Memo

Subject: The Village Precinct, Alphington

As requested, please find below comment on the concept plans submitted for the Village Precinct.

GRADING 03
ALTERNATE ACCESS CONSIDERATIONS

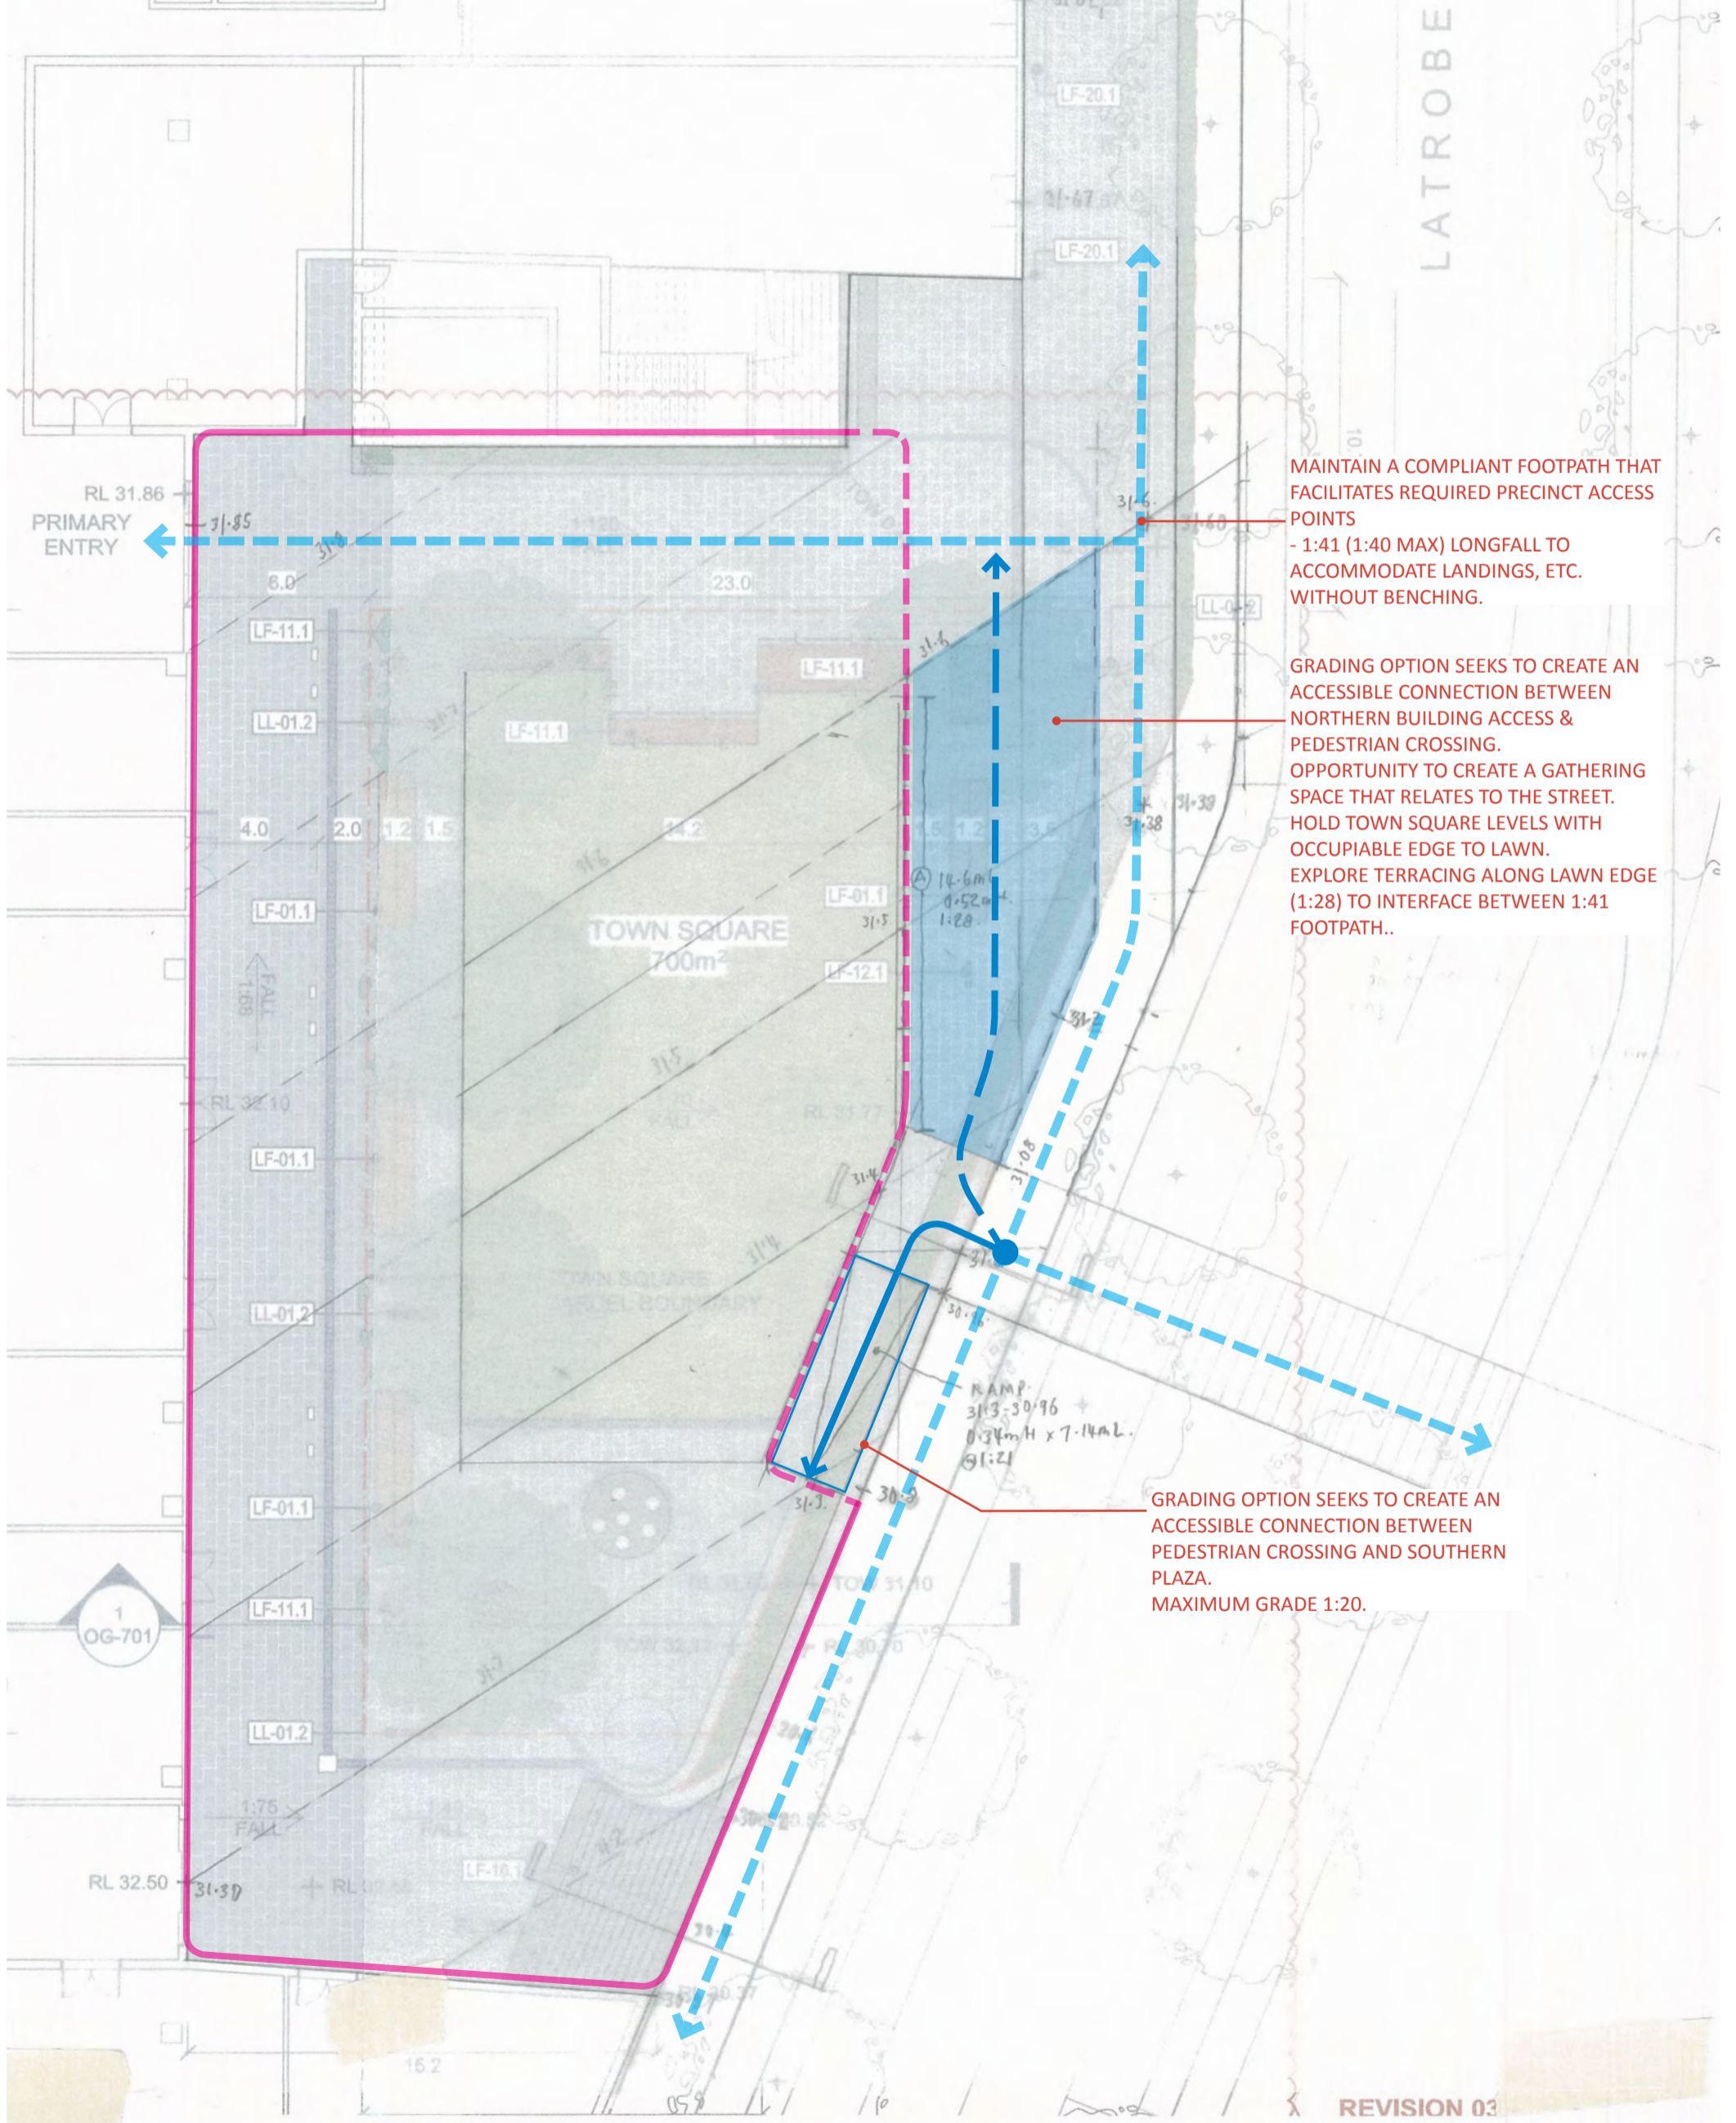
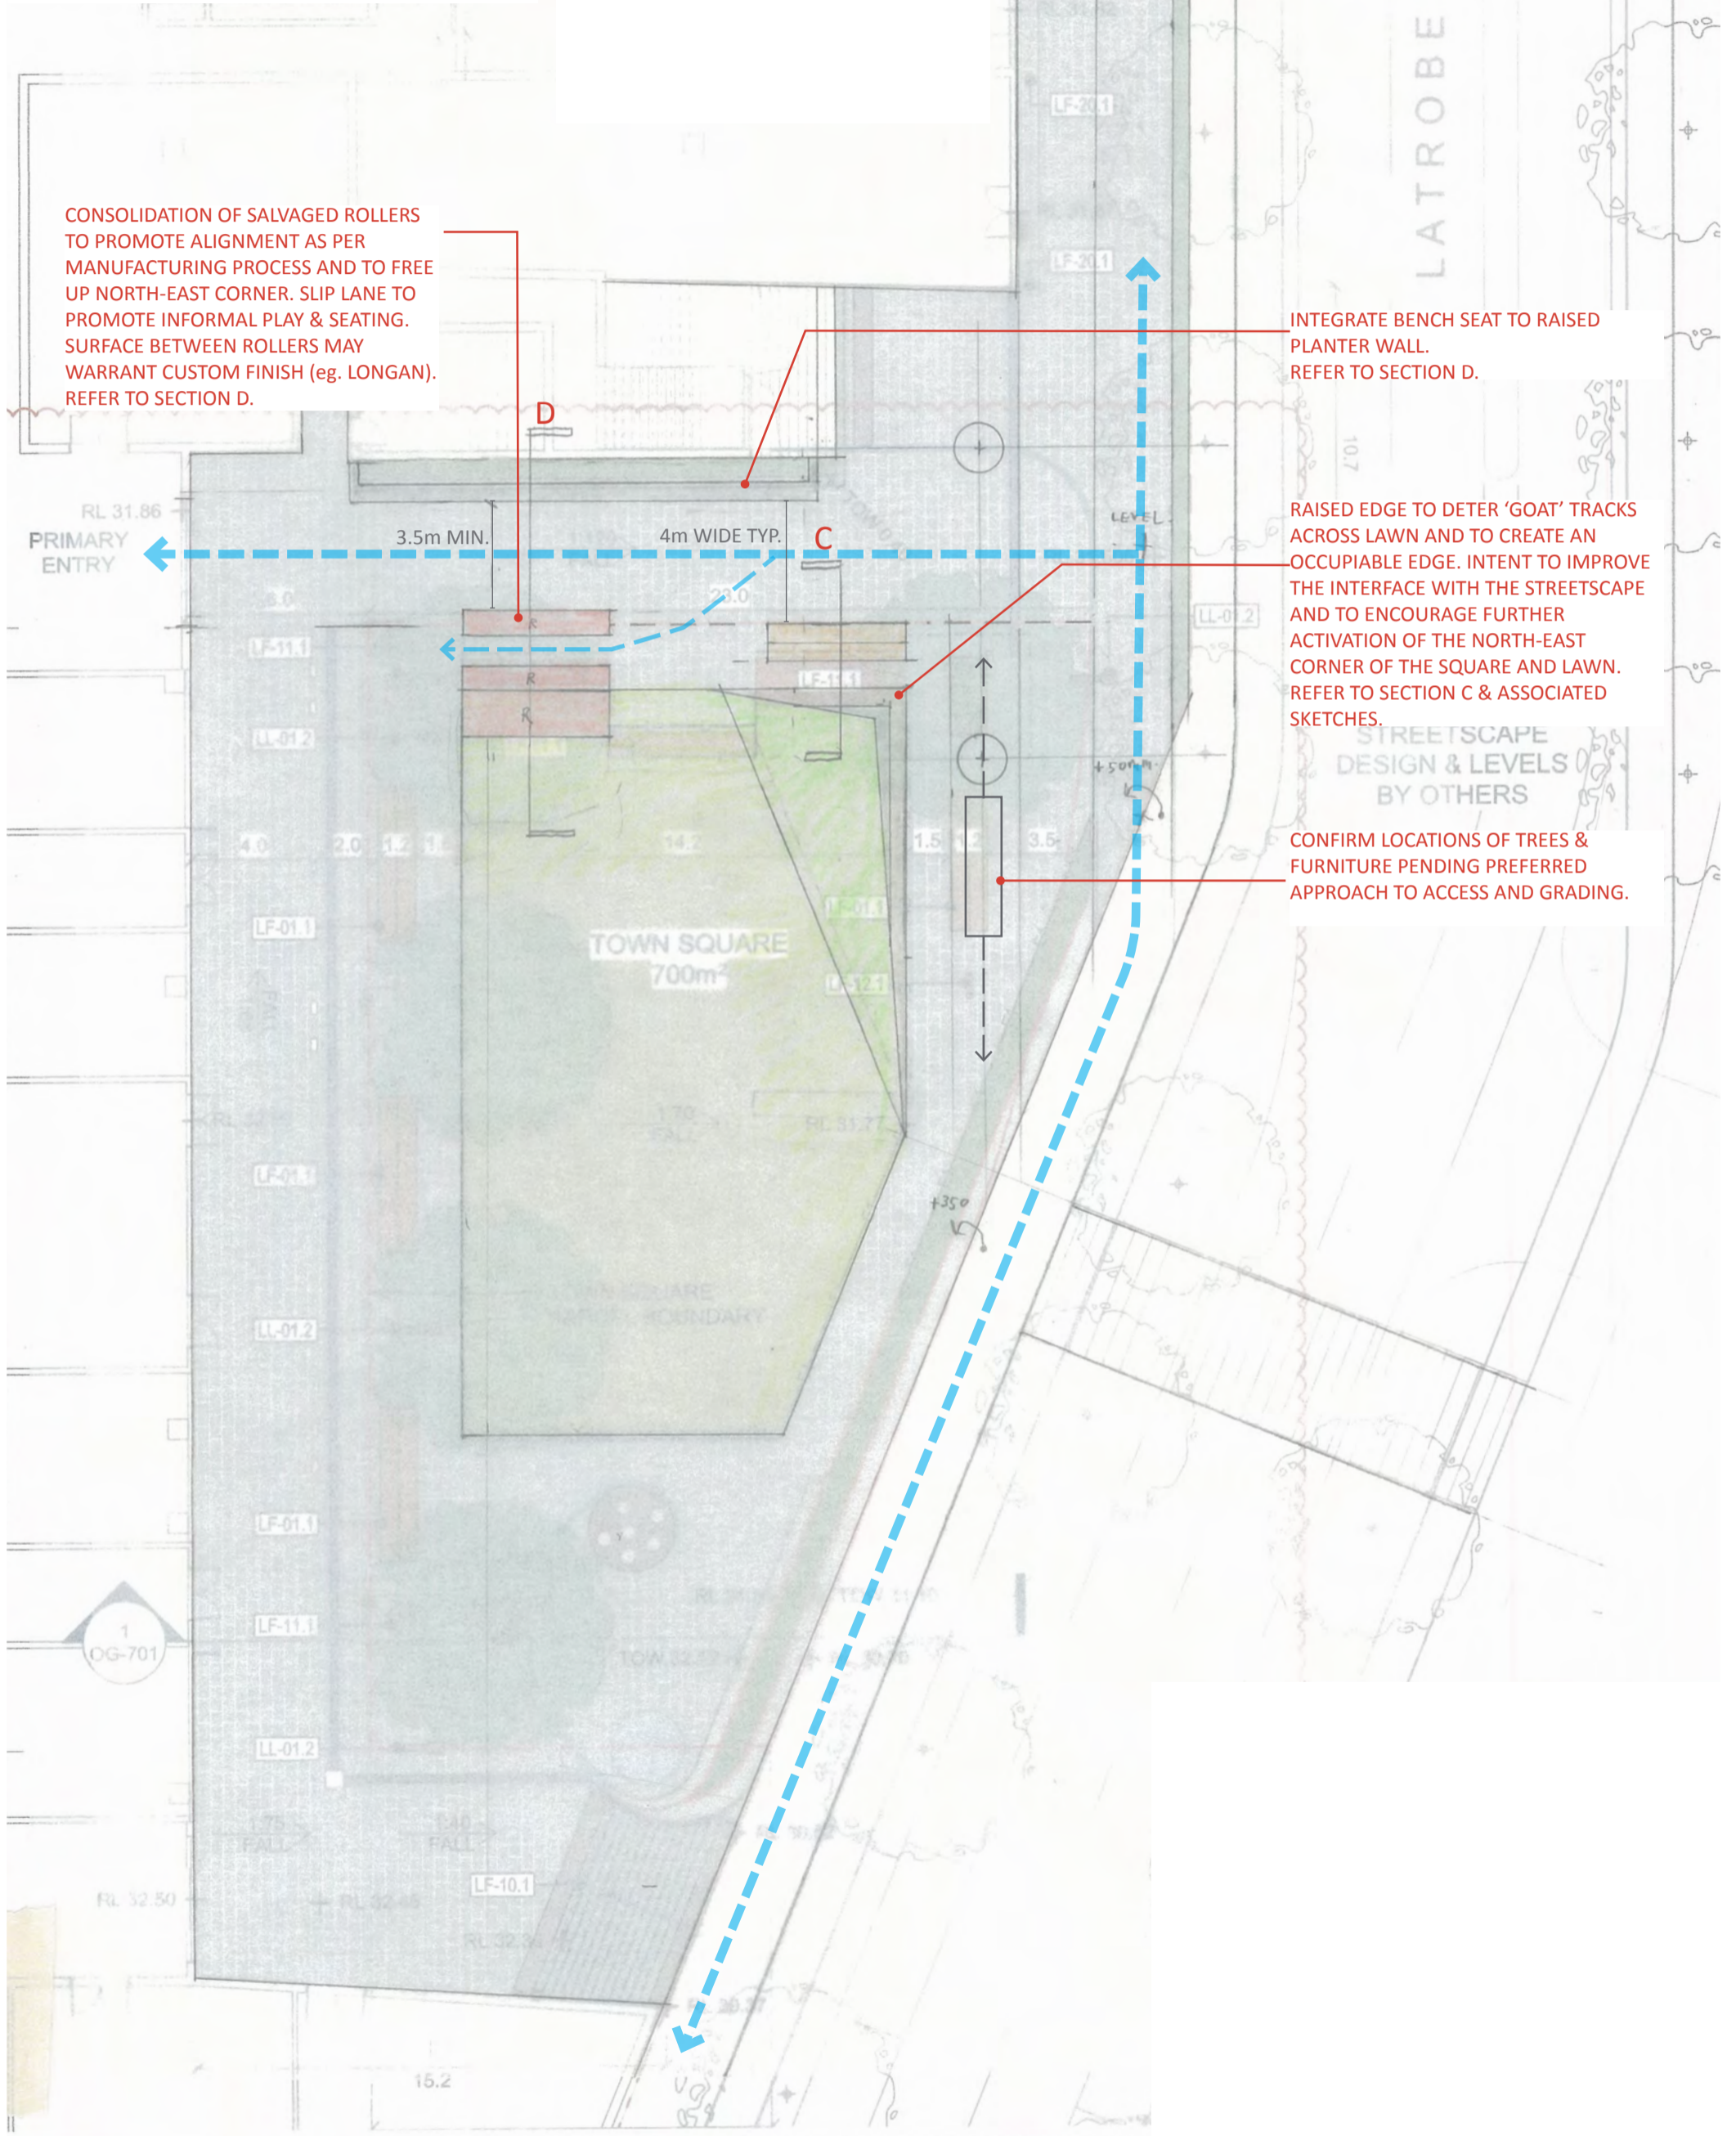
- Improve connectivity between La Trobe Avenue pedestrian crossing and Town Square - Objective is to offer a pedestrian connection into the Square at this location (Refer to attached Grading sketch 03 Alternate Access Considerations).

MAINTAIN A COMPLIANT FOOTPATH THAT FACILITATES REQUIRED PRECINCT ACCESS POINTS
- 1:41 (1:40 MAX) LONGFALL TO ACCOMMODATE LANDINGS, ETC. WITHOUT BENCHING.

GRADING OPTION SEEKS TO CREATE AN ACCESSIBLE CONNECTION BETWEEN NORTHERN BUILDING ACCESS & PEDESTRIAN CROSSING.
OPPORTUNITY TO CREATE A GATHERING SPACE THAT RELATES TO THE STREET. HOLD TOWN SQUARE LEVELS WITH OCCUPIABLE EDGE TO LAWN.
EXPLORE TERRACING ALONG LAWN EDGE (1:28) TO INTERFACE BETWEEN 1:41 FOOTPATH..

GRADING OPTION SEEKS TO CREATE AN ACCESSIBLE CONNECTION BETWEEN PEDESTRIAN CROSSING AND SOUTHERN PLAZA.
MAXIMUM GRADE 1:20.
